**DOCUMENT 00 90 00
ADDENDUM**

ADDENDUM NO. [2] Date: October 10, 2019

**RE: LANESBORO PUBLIC SCHOOLS
 ADDITION AND REMODEL REBID
 100 KIRKWOOD ST EAST
 LANESBORO, MN 55949
 HSR 18063**

**FROM: HSR Associates, Inc
 100 Milwaukee Street
 La Crosse, WI 54603
 (608) 784-1830**

LANESBORO PUBLIC SCHOOLS
ADDITION & REMODEL - RBID
 Project Location: 204 KIRKWOOD ST EAST
 LANESBORO, MN 55949
 Sheet Title: **ELEVATIONS**

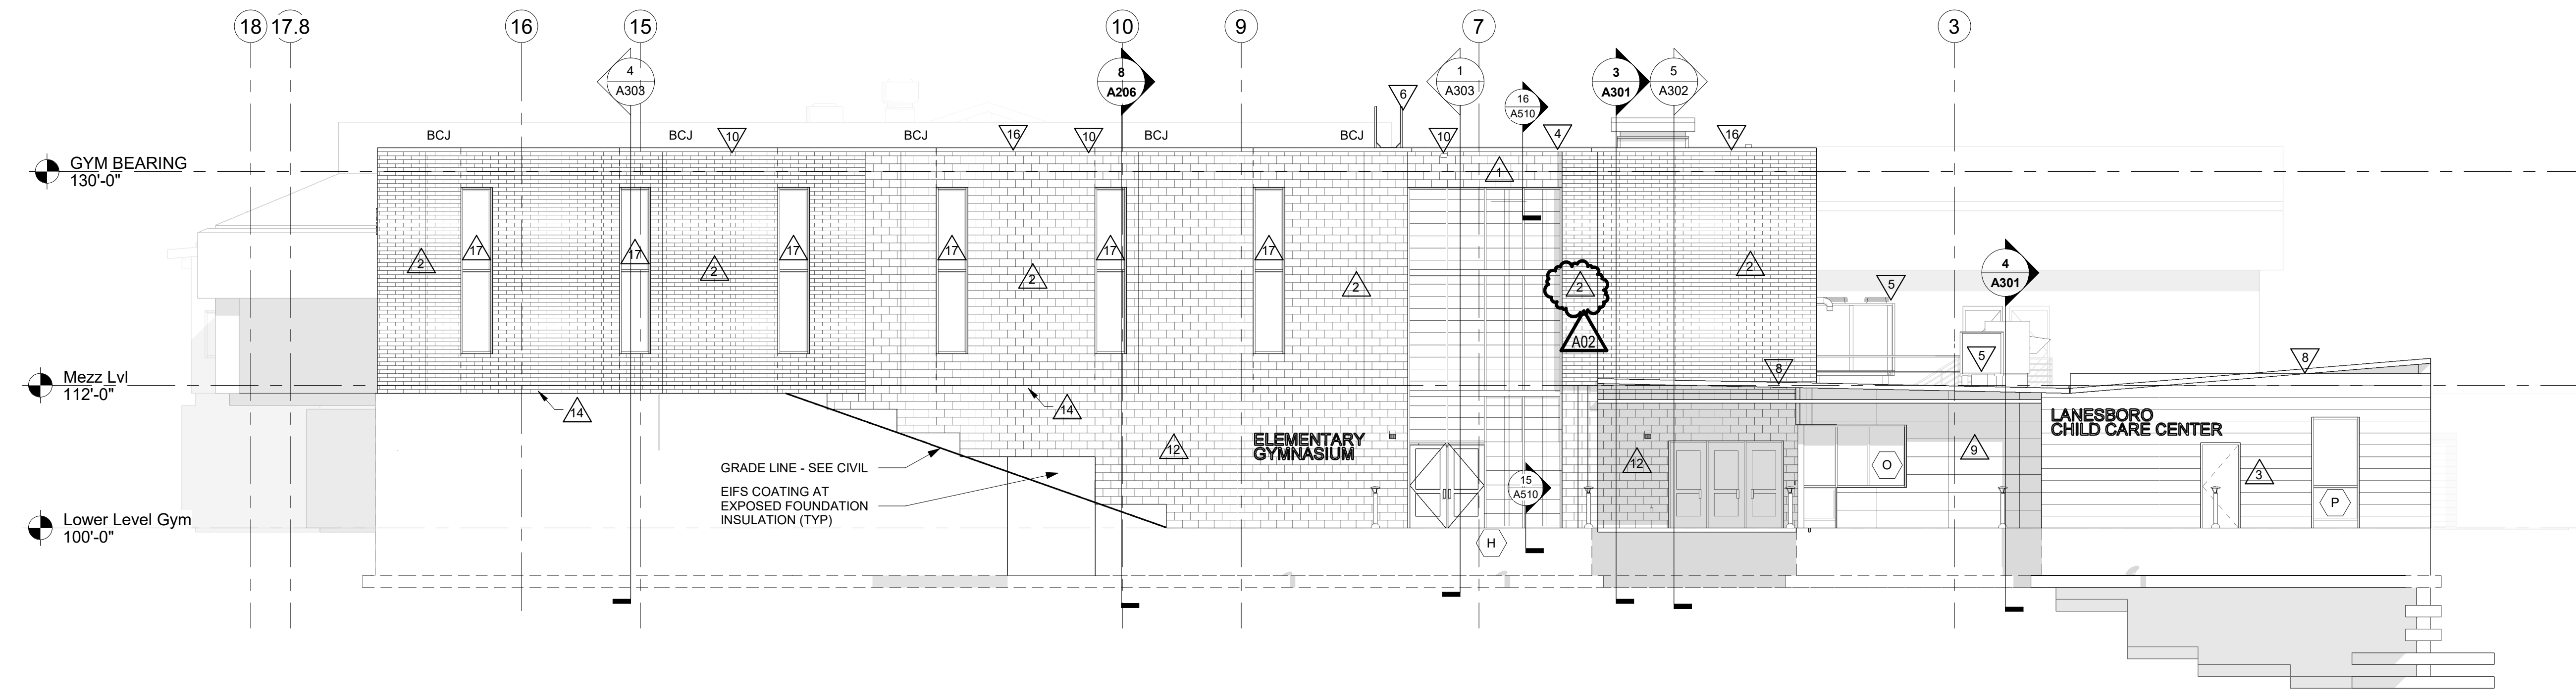
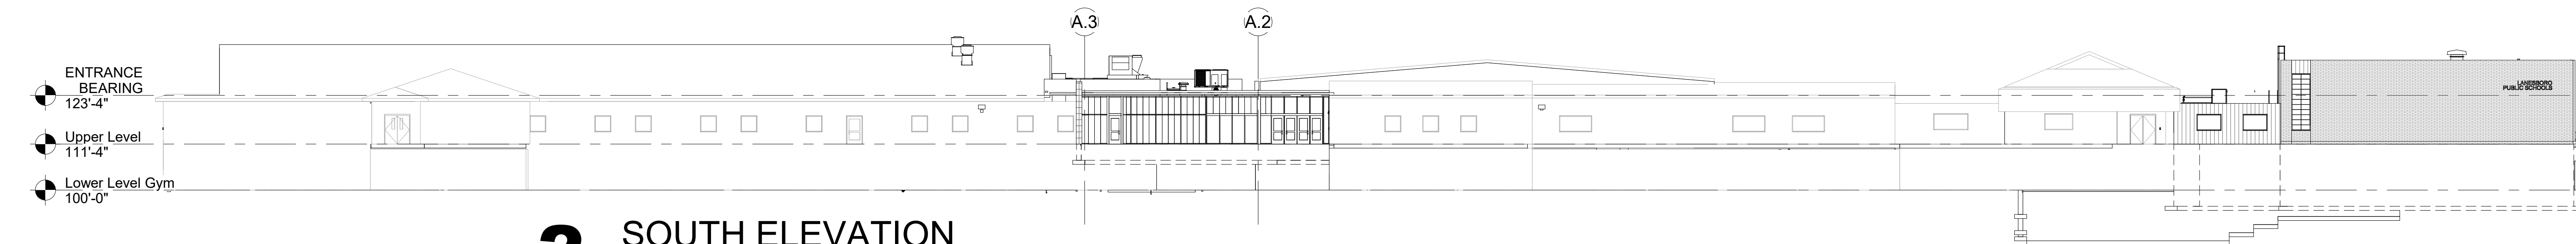
- a. Revisions clouded on Drawing.
 - b. Wall finish corrected.
30. Sheet A201 ELEVATIONS 30 x 42 attached hereto
 - a. Revisions clouded on Drawing.
 - b. Wall finish corrected at 1A201

A305

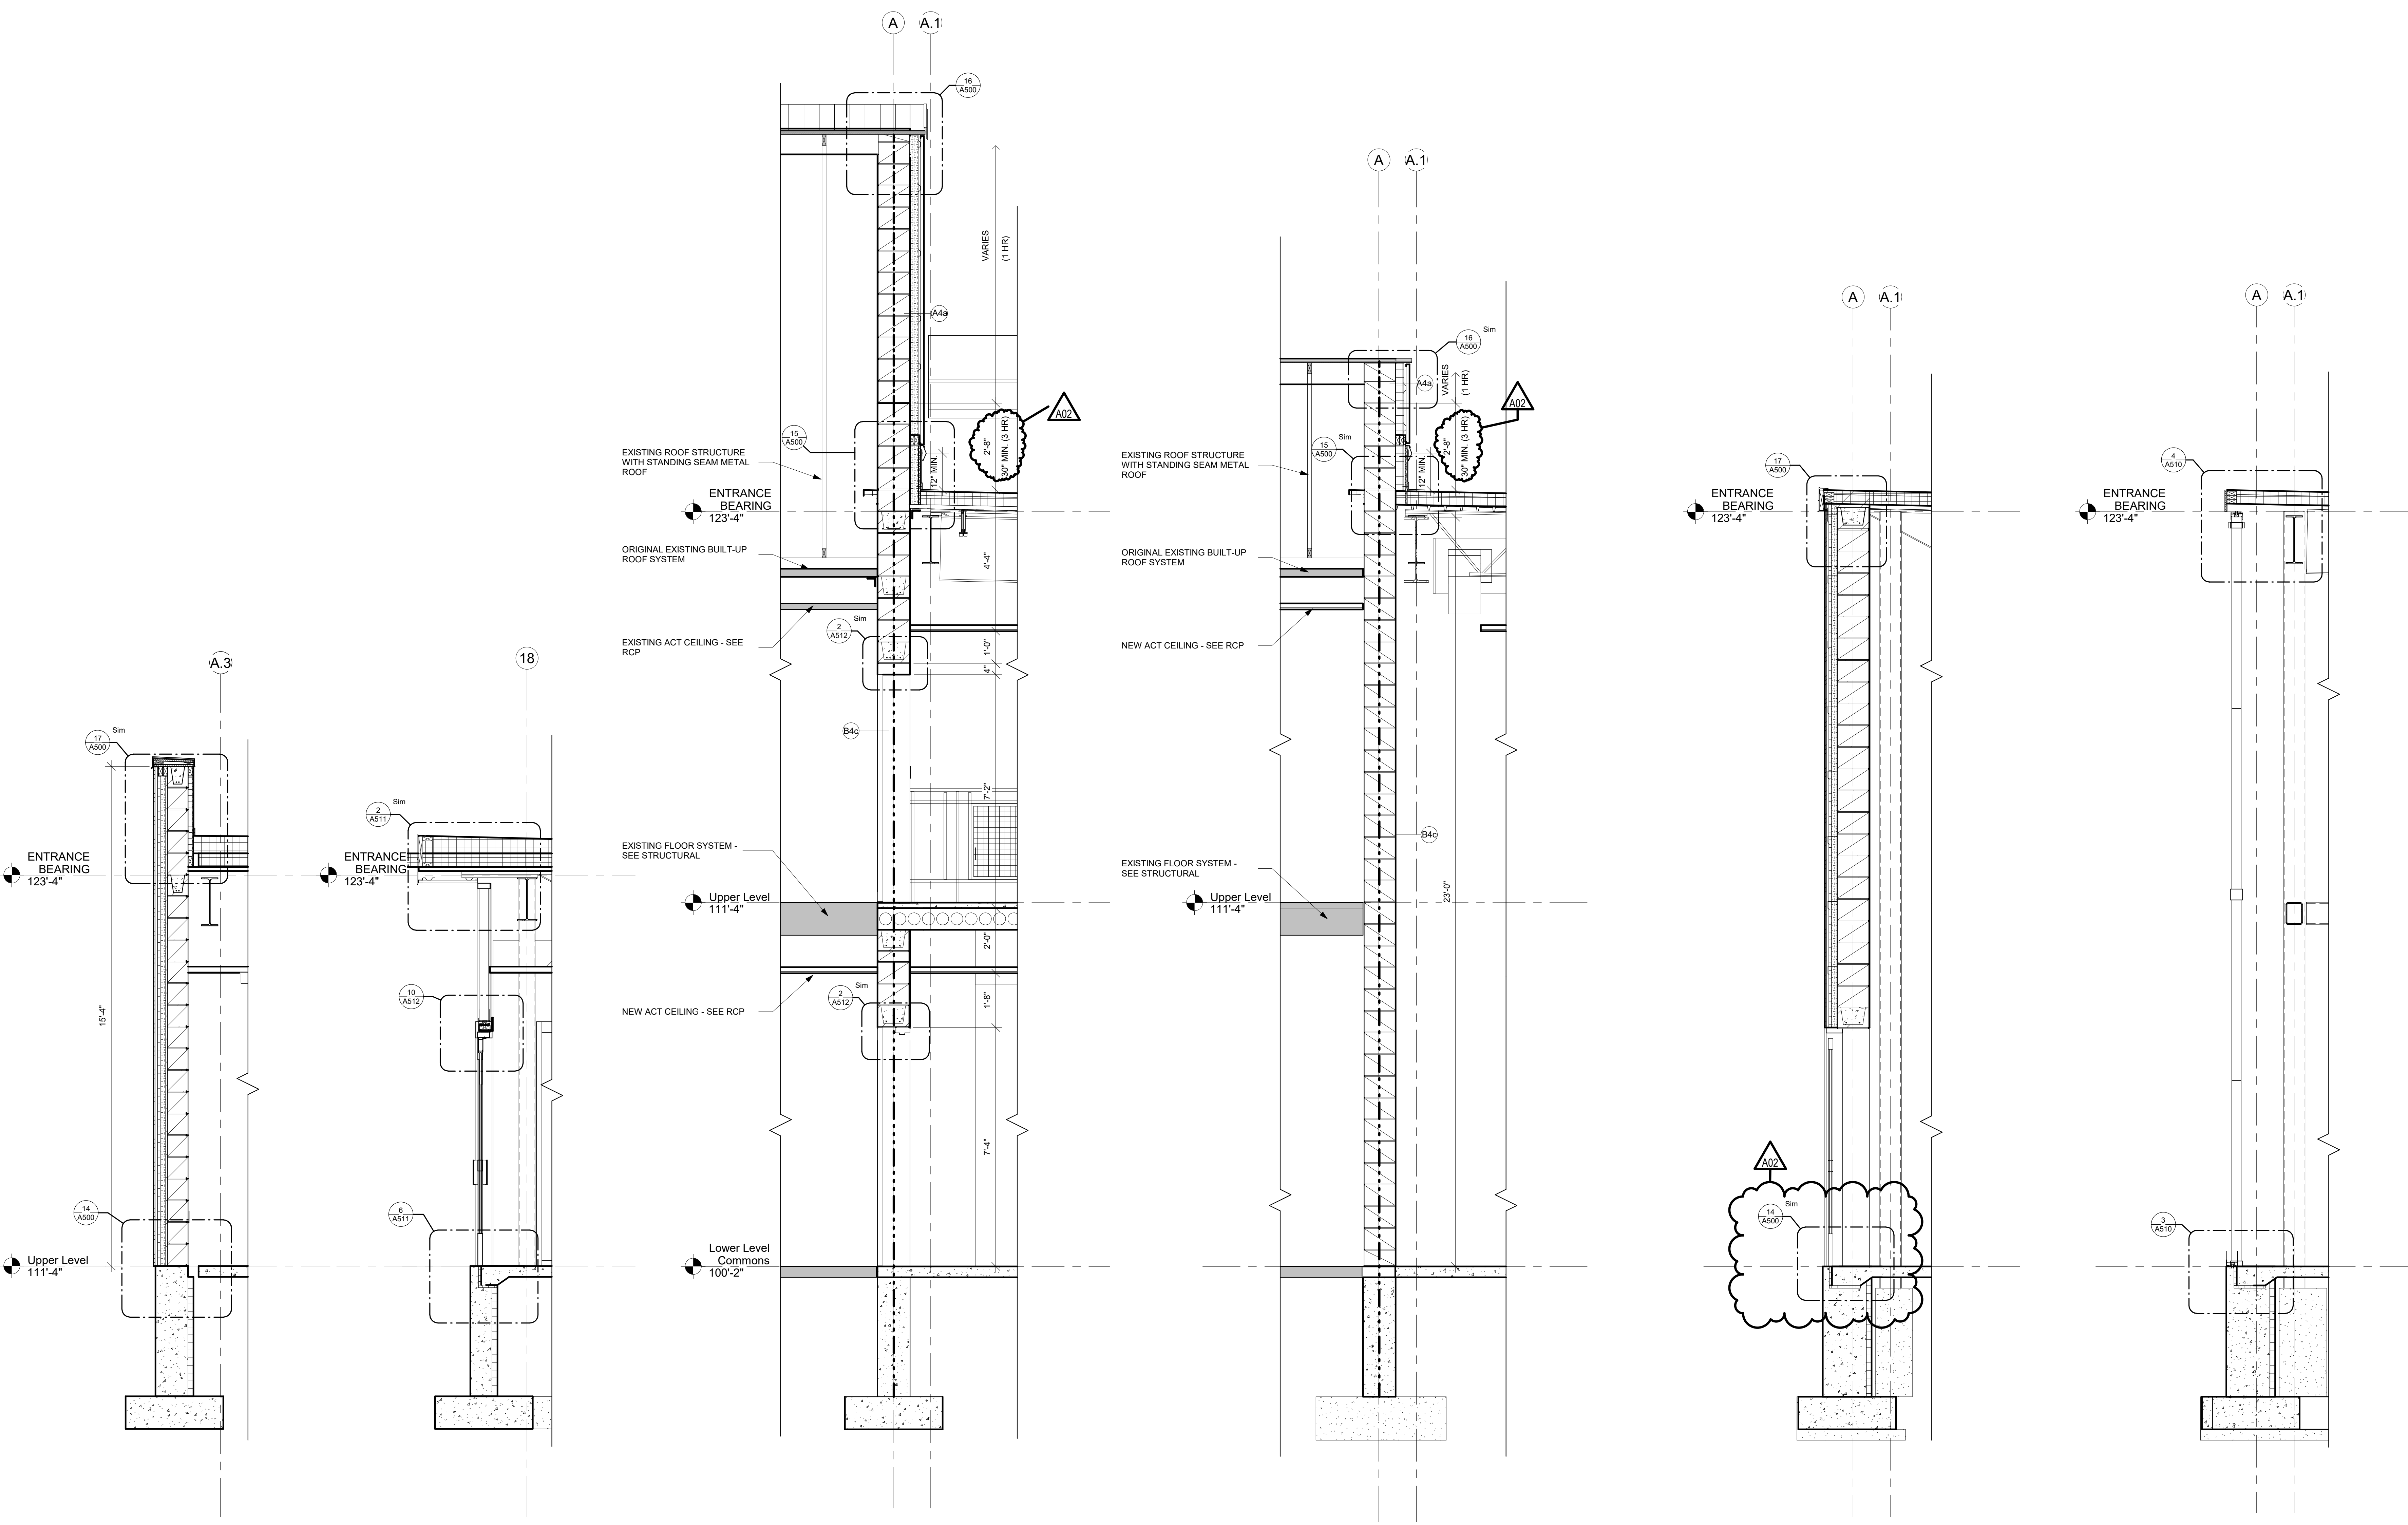
32. Sheet A305 WALL SECTIONS 30 x 42 attached hereto
 - a. Revisions clouded on Drawing.
 - b. Foundation detail revised at door in 5a305.
 - c. Code required extension of 3 hour wall indicated at 3 and 4A305.
